Office Action Summary	Application No. 10/563,422	Applicant(s) JACOBSEN, PER	
	Examiner BASIL KATCHEVES	Art Unit 3635

DETAILED ACTION

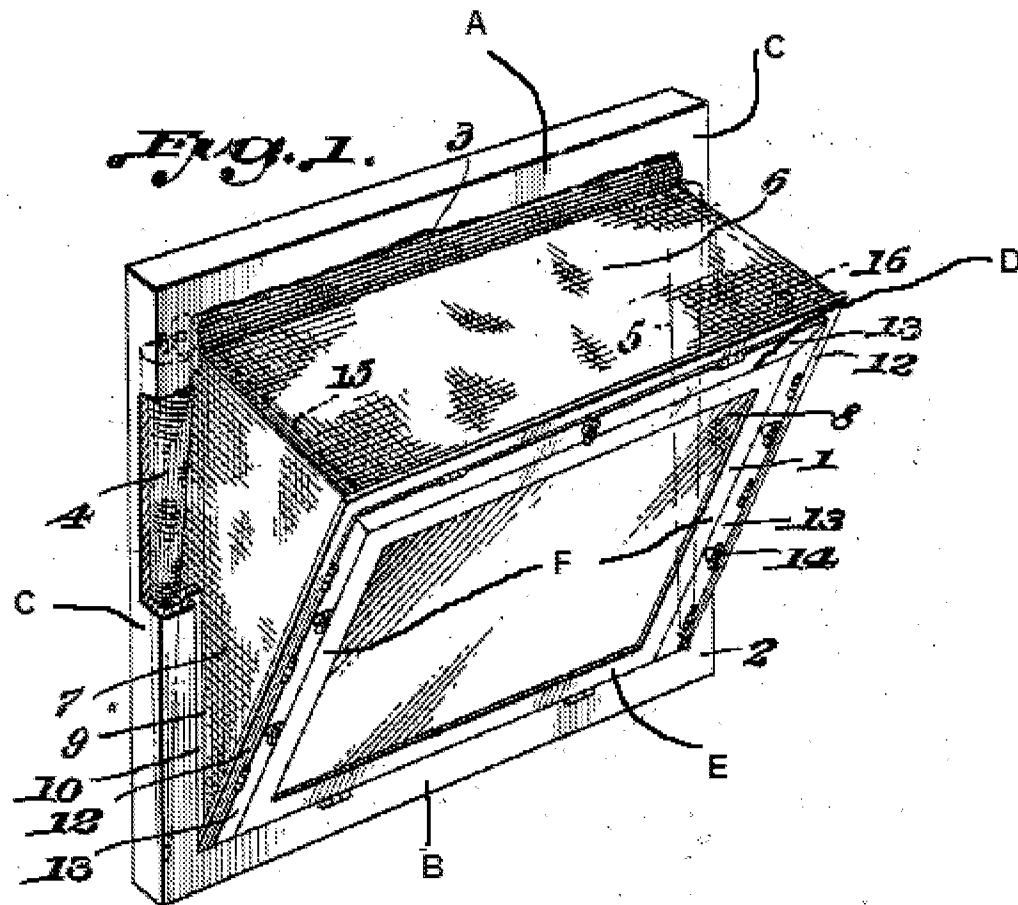
2. **Claims 18, 19 are rejected under 35 U.S.C. 102(b) as being anticipated by Persson (US Patent 2,311,413) as in the previous action.**

3. Persson discloses a window (see Fig. 1 below) comprising a frame (2) having a top member (A), a bottom member (B) and two side members (C) defining a frame

plane; a sash (1) having a top member (D), a bottom member (E) and two side members (F) defining a sash plane; a screening arrangement (7); the sash being connected to the frame by means of at least one hinge (Column 1, lines 58-60) connection to provide a hinge axis substantially parallel with the frame top member and the sash top member, such that the sash may be moved from a closed position to a ventilating position, in which ventilating position the sash plane forms an angle within a limited angle range with the frame plane to provide at least one ventilating Aperture, said screening arrangement covering said at least one ventilating aperture at least partly in the ventilating position; said screening arrangement comprising at least one screening element (7) which in closed position of the window, is arranged in an inactive position at the interface (12 – Fig. 2) between frame and sash, and in the ventilating position spans the ventilating aperture between the frame bottom member and the sash bottom member, and/or between the frame top member (A) and the sash top member (D), and that the at least one screening element is connected with the sash or frame top or bottom member and is in releasable engagement (13) with the corresponding frame or sash member within said limited angle range, wherein said at least one screening element is provided exclusively at the top and/or bottom member of the sash and the frame (as shown in Fig. 1 below); wherein the at least one screening element of the screening arrangement is adapted to be moved automatically from an inactive position corresponding to the closed position of the window to an active position corresponding to the ventilating position, and from the active position to the inactive position when the window is brought from its ventilating position to its closed position (Column 1, lines 16 -

20); wherein the screening arrangement further comprises interface screening means arranged at the interface between the screening element and the sash side members (F).
